World Forum for Harmonization of Vehicle Regulations**Working Party on Noise and Tyres****Seventy-ninth session**

Tyres: UN Regulation No. 117 (Tyre rolling resistance, rolling noise and wet grip)**Proposal for Supplement 16 to the 02 series of amendments
to UN Regulation No. 117****Submitted by the experts from the European Tyre and Rim Technical
Organization***

Figure 1
Minimum requirements for test surface area. The shaded part is called "Test area"

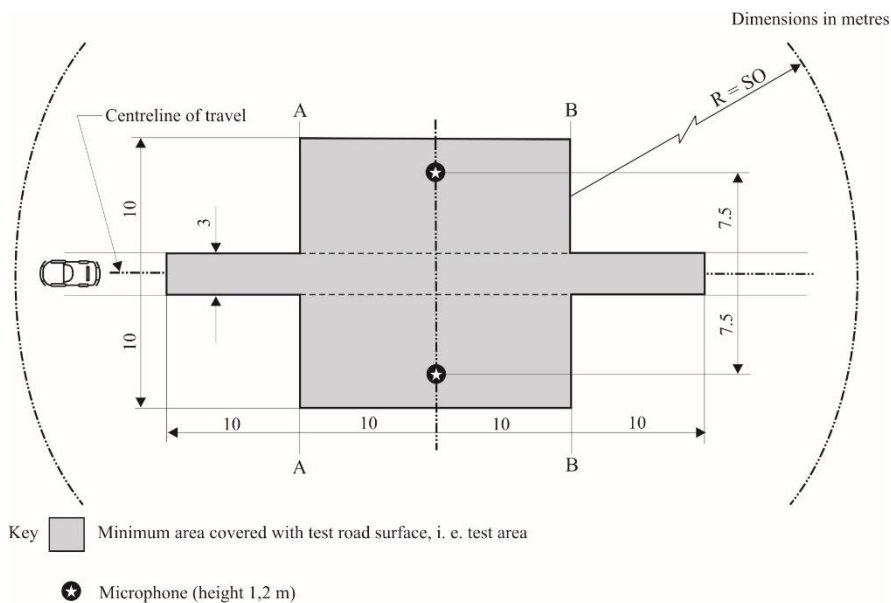
Annex 4, amend to read:

~~Reserved Specifications for the test site¹~~

~~When designing the test track layout it is important to ensure that, as a minimum requirement, the area traversed by the vehicles running through the test strip is covered with the specified test material with suitable margins for safe and practical driving. This will require that the width of the track is at least 3 m and the length of the track extends beyond lines AA and BB by at least 10 m at either end. Figure 1 shows a plan of a suitable test site and indicates the minimum area which shall be machine laid and machine compacted with the specified test surface material. According to Annex 3, paragraph 3.2., measurements have to be made on each side of the vehicle. This can be made either by measuring with two microphone locations (one on each side of the track) and driving in one direction, or measuring with a microphone only on one side of the track but driving the vehicle in two directions. If the latter method is used, then there are no surface requirements on that side of the track where there is no microphone.~~

8. In line with the amendment adopted at the seventy-eighth session of the Working Party on Noise and Tyres (GRBP) for Supplement 2 to the 04 series of amendments to UN Regulation No. 117 (informal document GRBP-78-05 replacing ECE/TRANS/WP.29/GRBP/2023/19), we propose to introduce a new temperature correction formula for the rolling sound emissions of tyres of classes C1 and C2 and to remove the content of the now obsolete Annex 4 as well as all its references.

Figure 2
Grading curve of the aggregate in the asphaltic mix with tolerances

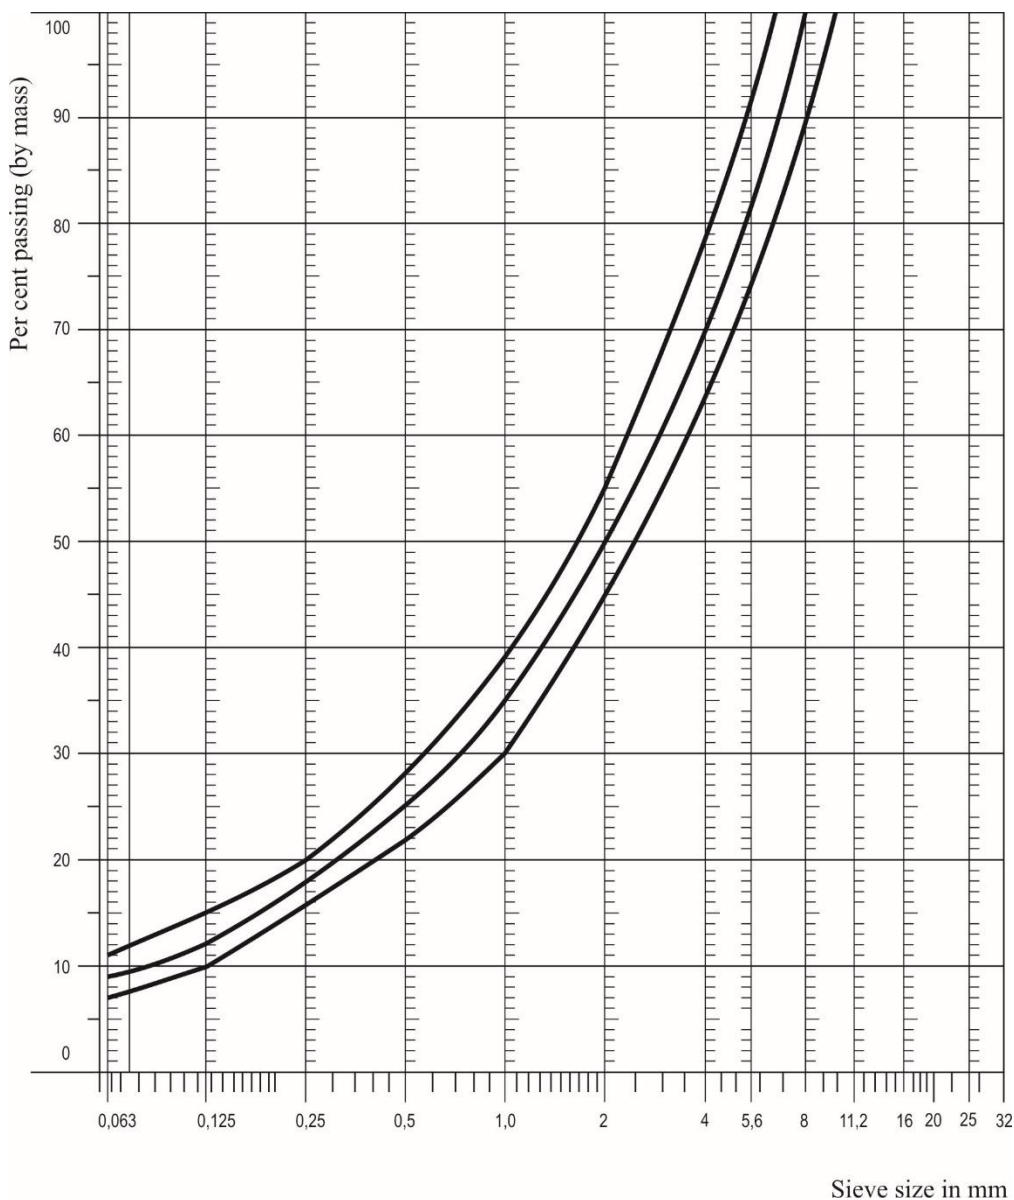
As a guide to the surface constructor, an aggregate grading curve which will give desired characteristics is shown in Figure 2. In addition, Table 1 gives some guidelines in order to obtain the desired texture and durability. The grading curve fits the following formula:

- (g) ~~The temperature of the mix before rolling shall be chosen so as to achieve by subsequent rolling the required voids content. In order to increase the probability of satisfying the specifications of paragraphs 2.1. to 2.4. above, the compactness shall be studied not only by an appropriate choice of mixing temperature, but also by an appropriate number of passings and by the choice of compacting vehicle.~~
